SHOP DRAWING REVIEW

Job Number: 57550
Reviewed By: G.S. Goodrich
Date: 2/8/2013

PROJECT NAME: JAMAICA	
PROJECT NUMBER: ER-BRF 013-1(16)	
PRECAST SUB-CAP PRODUCTION DRAWING SET	
DRAWING: PLAN LAYOUT & ELEVATION VIEW	
DRAWN BY: CD	DATE: 01/29/13
APPROVED BY: TD	SHEET: 1 OF 4

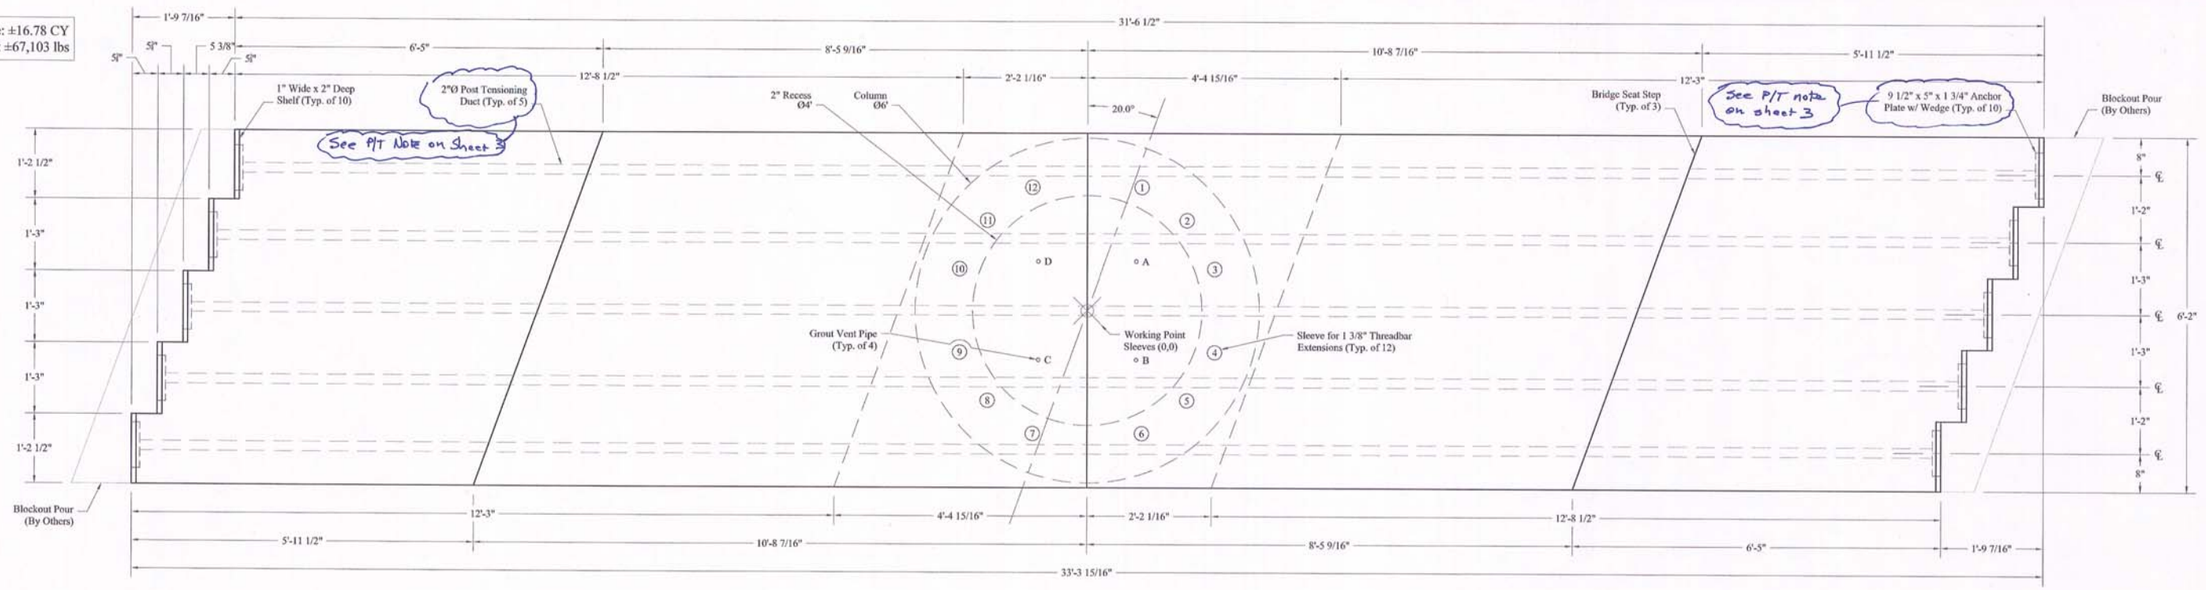
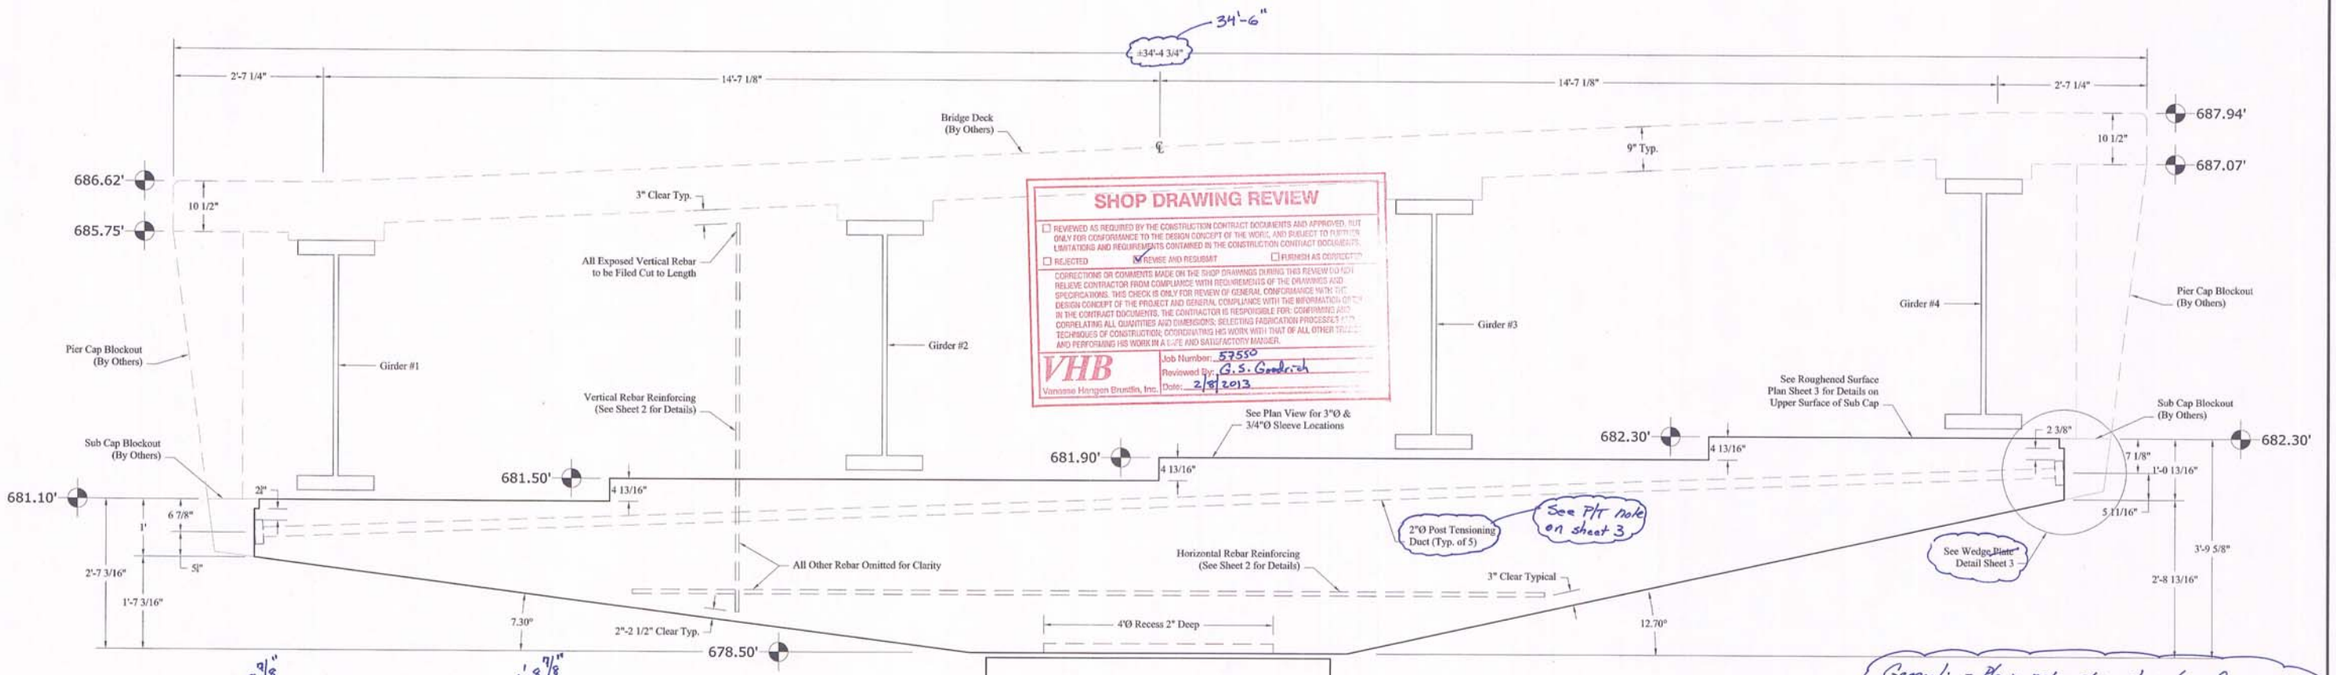
General: - Please note strength & days of concrete on the drawings.
- Please note type and distribution of reinforcing steel to be used in components.

Section B-B

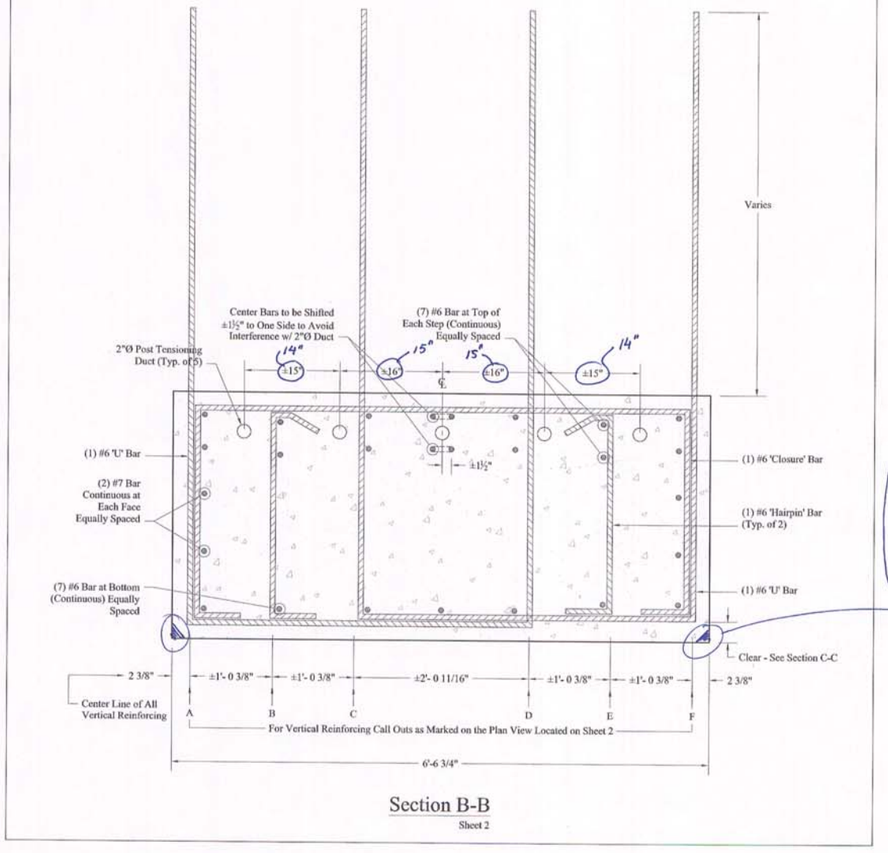
indicate minimum lap splice btwn. 6B7, 6B14 with 6B15 and 6B6, 6B13 with 6B20

confirm bar mark (461 on sheet 4?)

confirm bar mark (E22 on sheet 4?)

Wedge Plate Detail

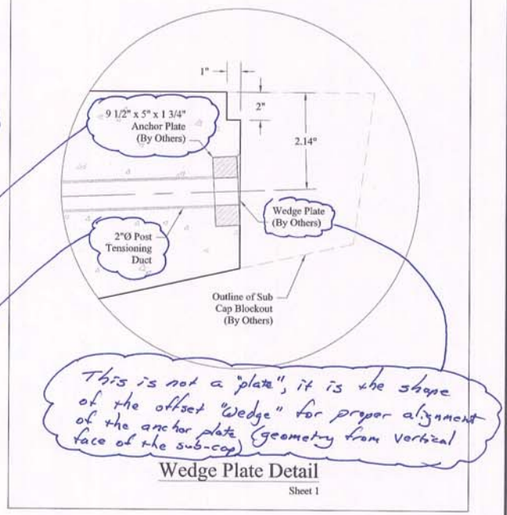
The Post-tensioning system, including anchor plate, and duct, shall conform to the Post-Tensioning special provision for this project. The anchor plate shall be embedded in the sub-cap as shown, and is part of a proprietary system as noted in the special provision (3 systems are approved for use in this project). The 2"ø duct is also specific to the p/t system. The p/t system proposed by the contractor shall be submitted for approval as noted in the special provision. Please note the system to be used on this project and submit the system components for approval.
